# UNITED STATES PATENT AND TRADEMARK OFFICE

APPLICATION NO.	FILING DATE	FIRST NAMED INVENTOR	ATTORNEY DOCKET NO.	CONFIRMATION NO.
10/047,581	10/23/2001	John H. Stevens	HRT-287	4692
27777	7590	05/01/2006	EXAMINER	
PHILIP S. JOHNSON JOHNSON & JOHNSON ONE JOHNSON & JOHNSON PLAZA NEW BRUNSWICK, NJ 08933-7003			ISABELLA, DAVID J	
			ART UNIT	PAPER NUMBER
			3738

<b>Office Action Summary</b>	<b>Application No.</b> 10/047,581	<b>Applicant(s)</b> STEVENS, JOHN H.	
	<b>Examiner</b> DAVID J. ISABELLA	<b>Art Unit</b> 3738

**FIG. 8**

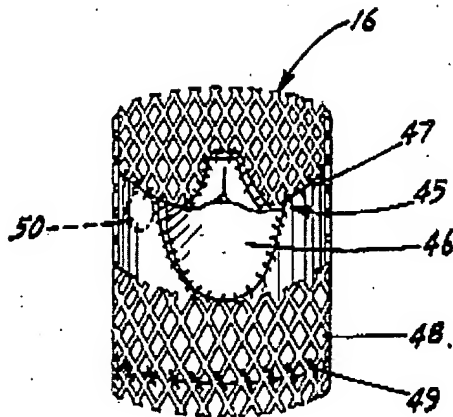
Ersek discloses a valve [45] for implantation within a mammal, comprising a flexible sleeve [portion of valve forming rim 45] having a proximal end, and a distal end and an outside surface; at least one cusp [46] configured; to permit blood flow through at least one cusp in a single direction; at least one ring [16] attached to the outside surface of the sleeve, the at least one ring being attached to a portion of the sleeve that is not everted; and at least one fastener extending in a direction radially outward with respect to the sleeve. See figure 8

Claim 21, see attachment of the ring to the valve in figures 8 and 9.
